City of El Paso – City Plan Commission Staff Report

REVISED

Case No: SUSU13-00079 – Mesquite Trails Unit 9
Application Type: Major Combination
CPC Hearing Date: September 5, 2013
Staff Planner: Harrison Plourde, 541-4114 (PlourdeHT@elpasotexas.gov)

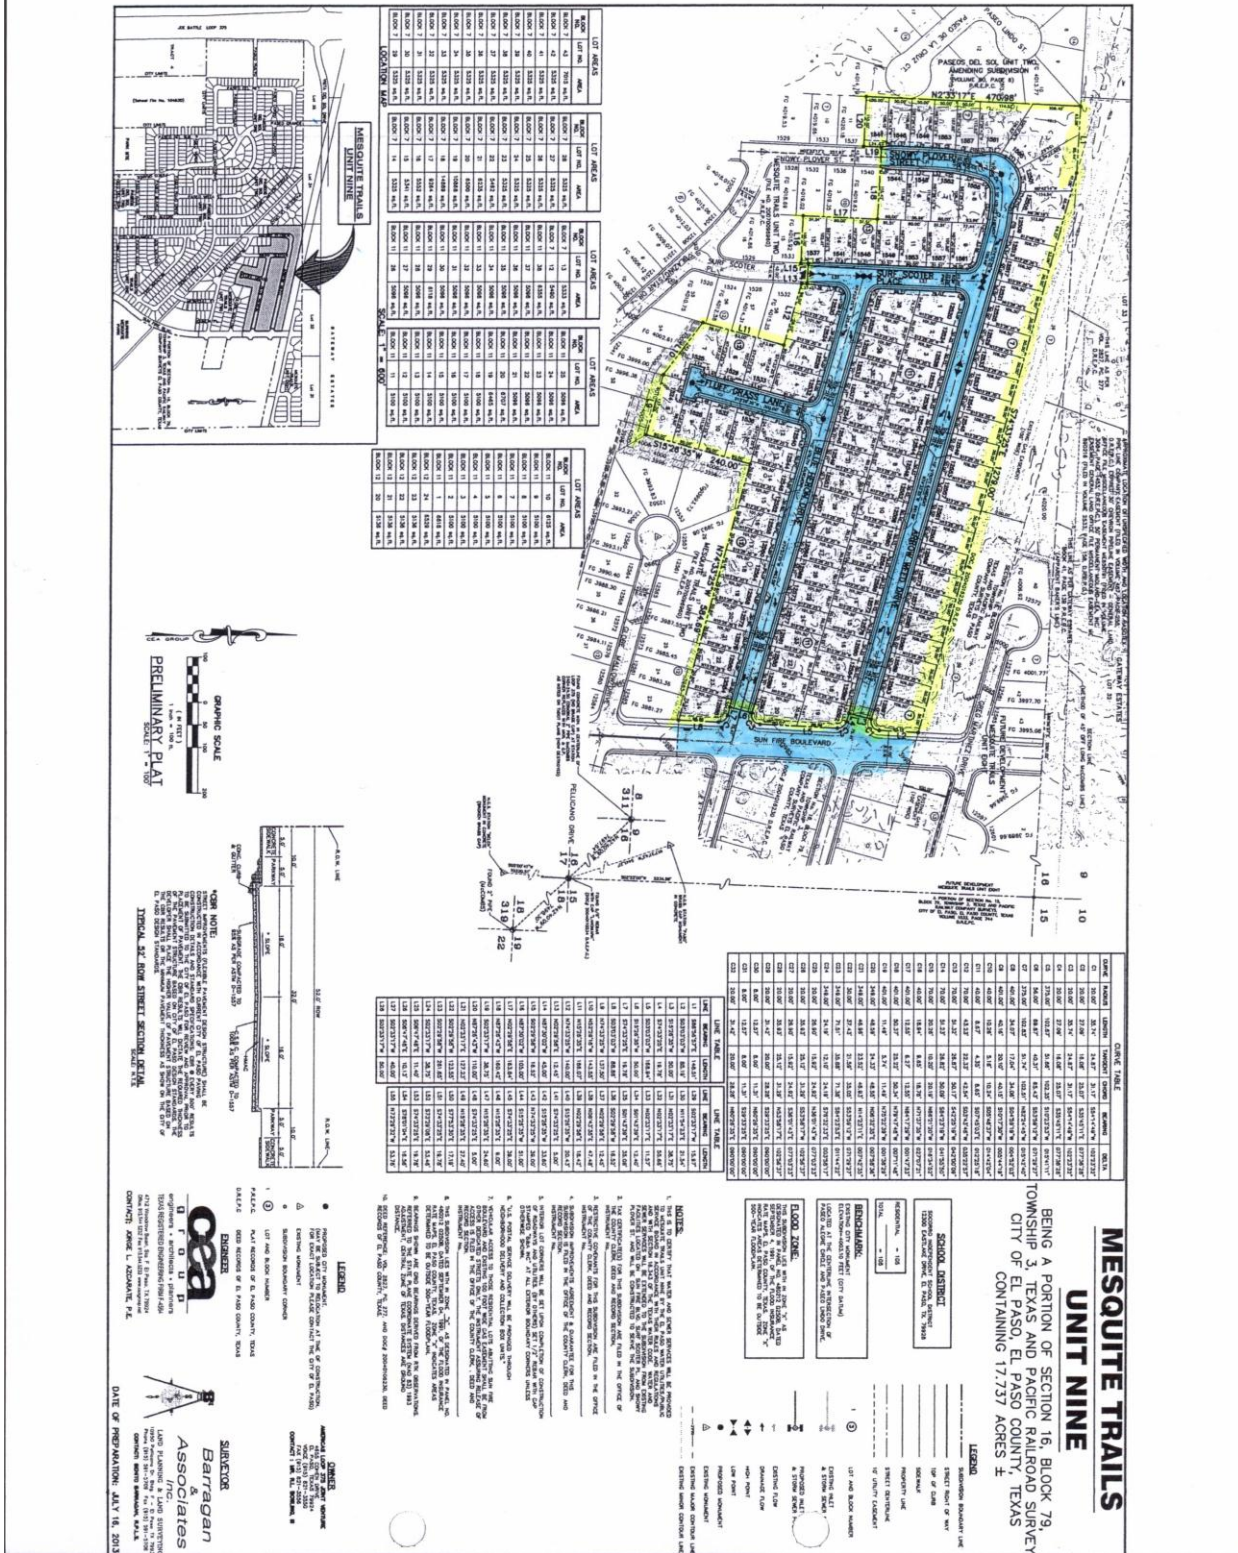
1. Relabel "Block 13" as "Block 10", as this is the label already provided in the portion of the block within Mesquite Trails Unit Two. Additionally, there is already a "Block 13" in Mesquite Trails Unit Three.
2. Relabel Lots 23 and 24 of Block 12. The portion of the block within Mesquite Trails Unit Two already has lots labeled 23 and 24 – blocks cannot have multiple lots with the same lot number on the same block.
3. Add lot numbers to new lots on Block 7.

MESQUITE TRAILS UNIT 9

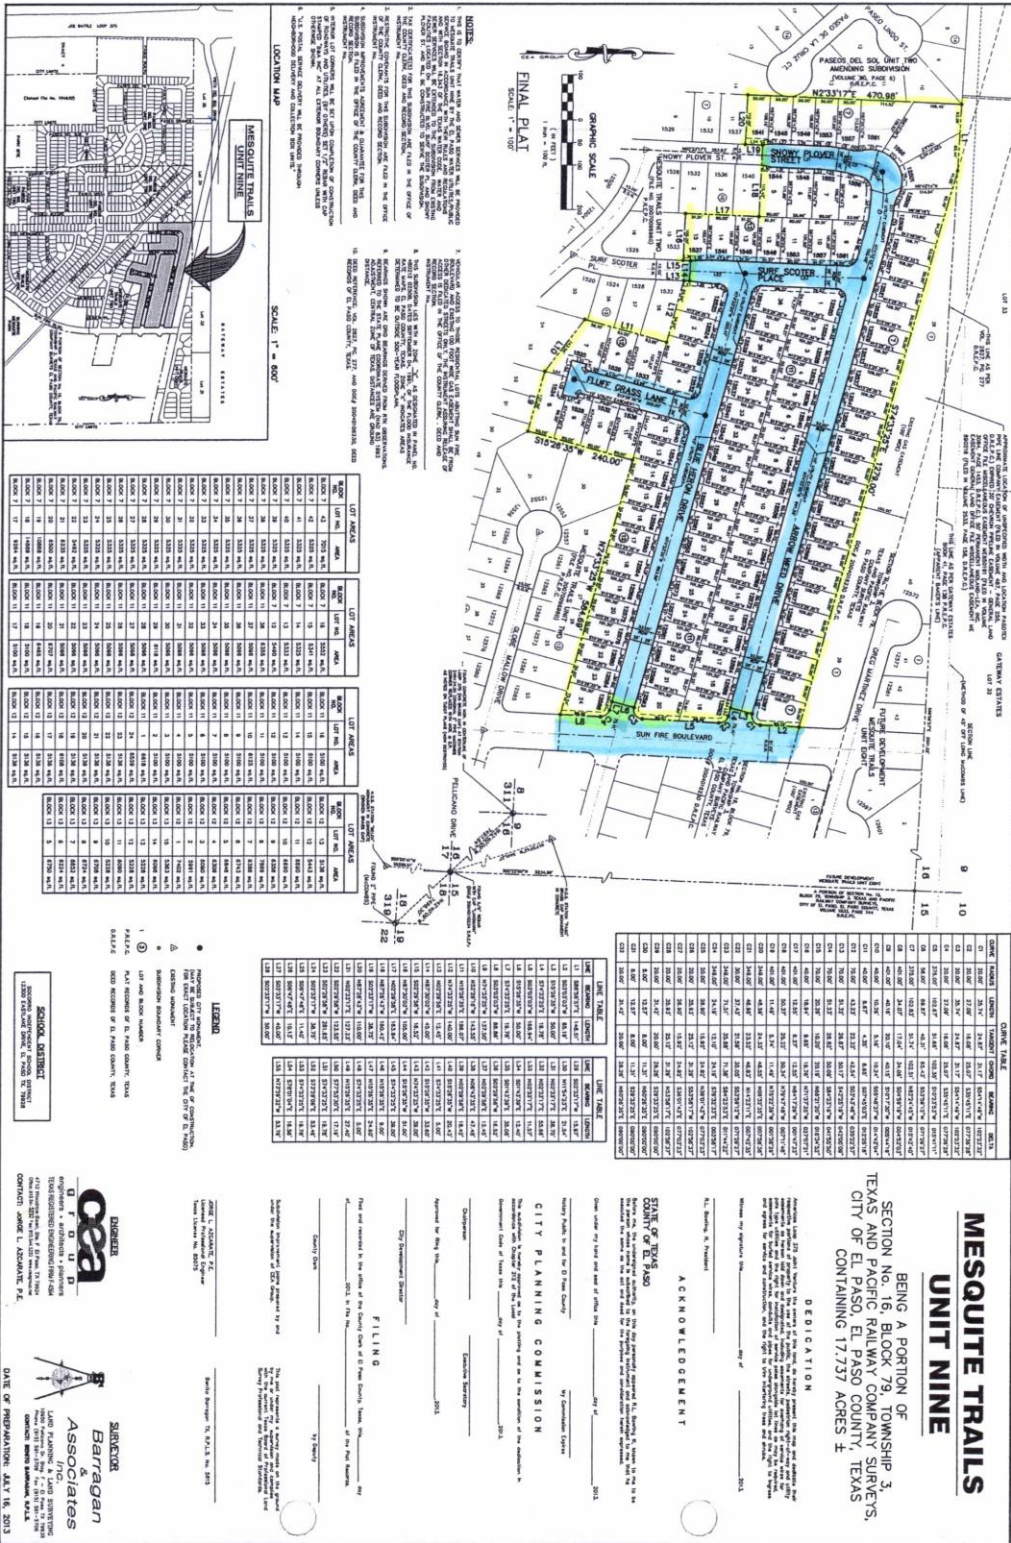
1. Allow for a modified 52 foot roadway cross-section that includes two 16 foot driving lanes, two 5 foot parkways and two 5 foot sidewalks.
2. Allow for a turning heel angle between 70°-110° at Snowy Plover Drive and Arrow Weed Drive.
